Mr Mee Access table prepared by Peter Cole of Ceres Property

Accesses - Retained Land Affected by Lower Thames Crossing

PLAN 9

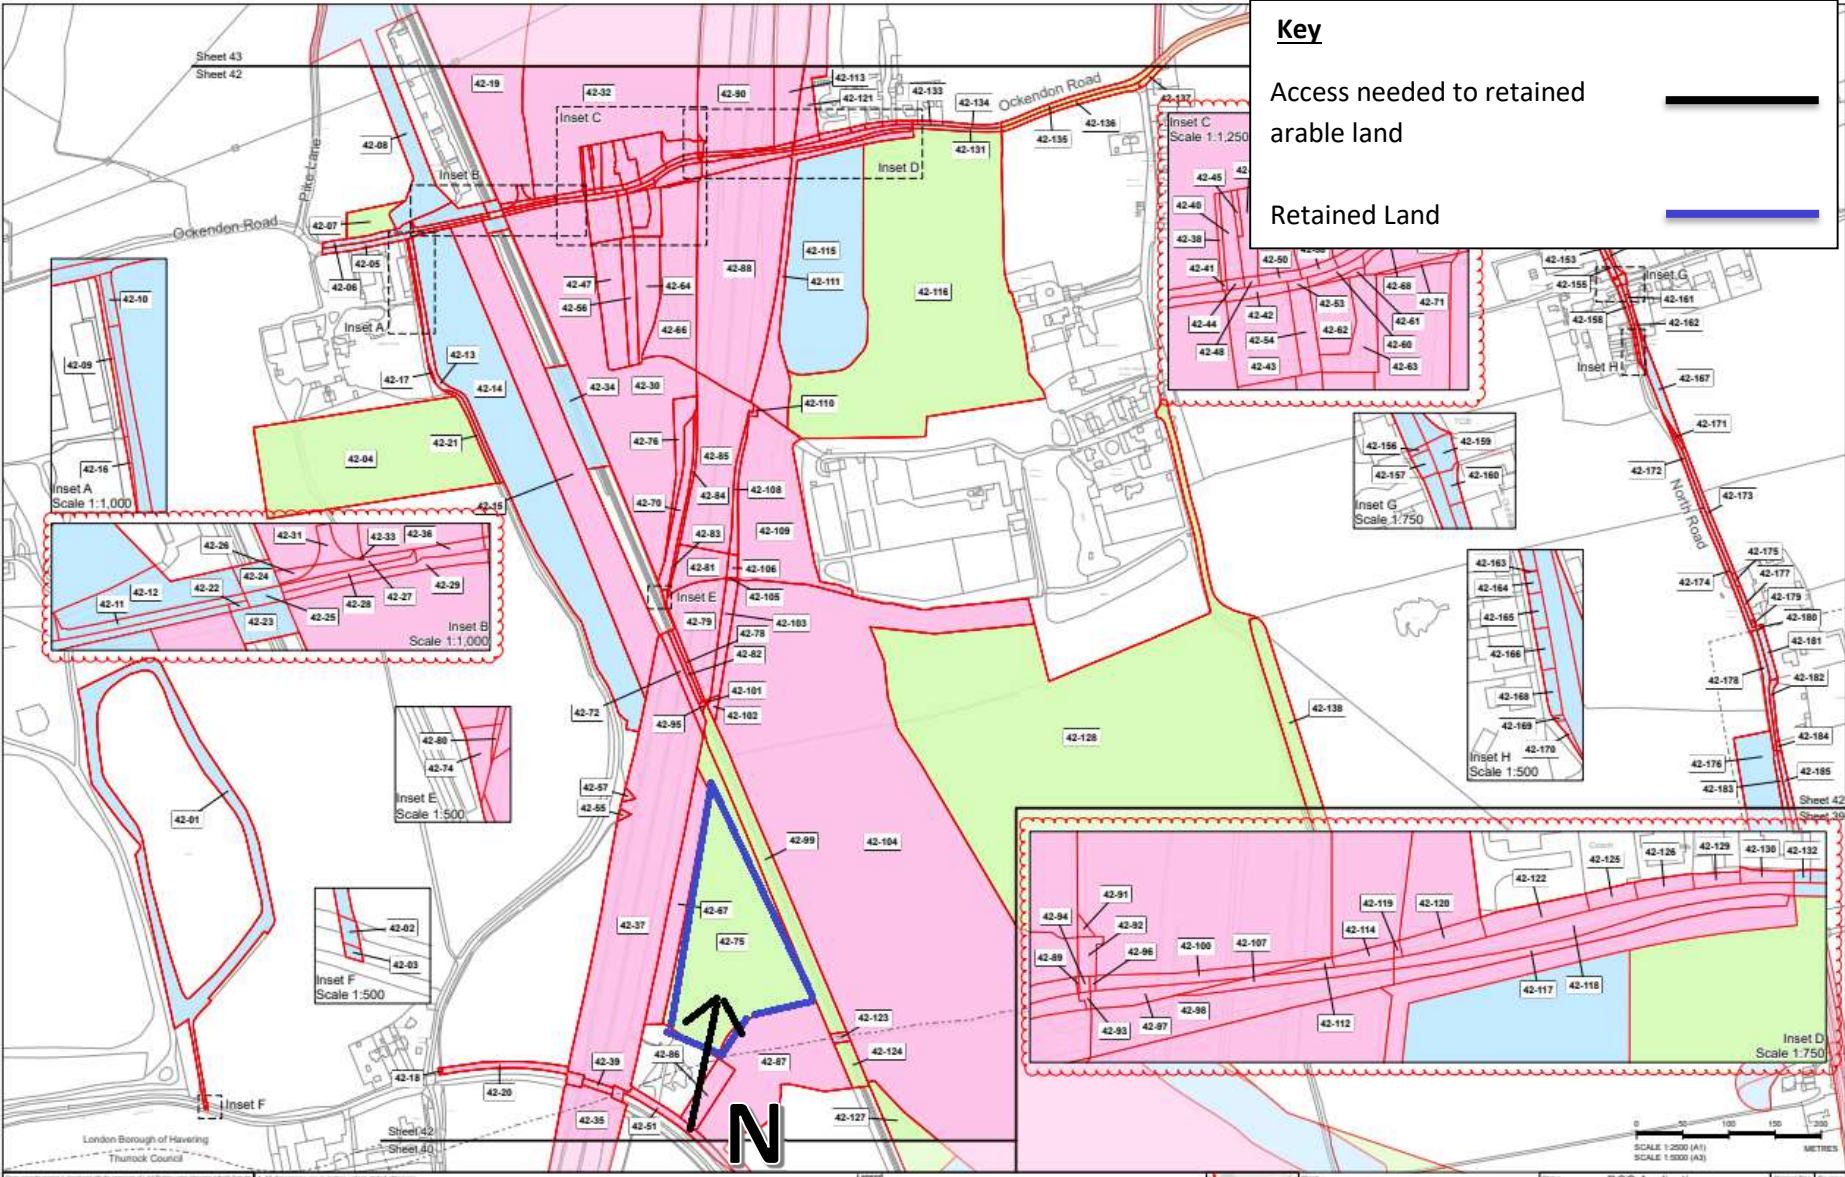
Applicant's Plan which has been annotated by Peter Cole	Plan 8	Plan 9
Current Access	Access to the fields outlined in purple is currently from Dennis Road. The access has a 10 meter width.	Access to the field outlined in purple is currently from the arable field to the south.
Applicant's proposed replacement access to allow continued use of retained arable land	Point M on the above plan but not provided by the Applicant.	Point N on the above plan
Description of Applicant's proposed replacement access	Access is barred.	There is no current access and this will be a new access
Current Access, Effects of LTC Scheme, and comments on the suitability of replacement access	The Applicant is proposing a new WCH which will block this access.	<p>A new WCH overpass on the Lower Thames Crossing will sever the current access to this land.</p> <p>The Applicant has currently designed a new access point to the severed arable land from Dennis Road.</p> <p>The Applicant is proposing a new WCH which will be in front of this new access.</p>

<p>Photo from Roadside</p>		
<p>Orientation of Photo</p>	<p>Looking north on Dennis Road with "Point M" on the right hand side</p>	<p>Looking north on Dennis Road at the proposed new access location - "Point N"</p>
<p>Result of lost access</p>	<p>There is no access provided by the Applicant. Without one Mr Mee cannot farm the land</p>	<p>The Applicant is creating a new access to replace the lost access but without seeing the detail on the design it is unclear if it will be suitable for Mr Mee to access and farm the land.</p>
<p>Mr Mee's need for new access</p>	<p>The existing access is sufficient for agricultural equipment and needs to remain.</p> <p>Suitable security measures i.e. a reinforced gate with poacher blocks to prevent unauthorised access will need to be installed. It is the case in this part of south Essex, near to a large urban conurbation and easy main routes of road access that the pressure from unauthorised users is evidently of such a degree that when barriers have been used, they have been damaged.</p>	<p>Access to this land is required of at least 5 metres in width and suitable for a turning circle to cater for farm vehicles and machinery (e.g. combine and tractor and trailers). This may need to be wider to comply with highway safety requirements i.e the need for visibility splays to ensure that it is safe.</p> <p>Access to the land will need to provide suitable security measures i.e. a reinforced gate with poacher blocks to prevent unauthorised access.</p> <p>It is the case in this part of south Essex, near to a large urban conurbation and easy main routes of road access that the</p>

<p>pressure from unauthorised users is evidently of such a degree that when barriers have been used, they have been damaged.</p> <p>A 5 metre width access track will be required to the severed land from the access.</p>
<p>Overall conclusions on Applicant Proposal for access</p>	<p>The Applicant has not provided an access to this land. The Applicant will need to provide:</p> <ol style="list-style-type: none"> 1. An access to the land in line with the specifications which is existing today. 2. Detailed design on the specification requested above 3. There is no detailed design on the how the WCH will interact with the access and how unauthorised access can be prevented. 	<p>The Applicant has suggested a new access to this land. The Applicant will need to provide:</p> <ol style="list-style-type: none"> 1. Detailed design on the specification requested above 2. There is no detailed design on the how the WCH will interact with the access and how unauthorised access can be prevented.
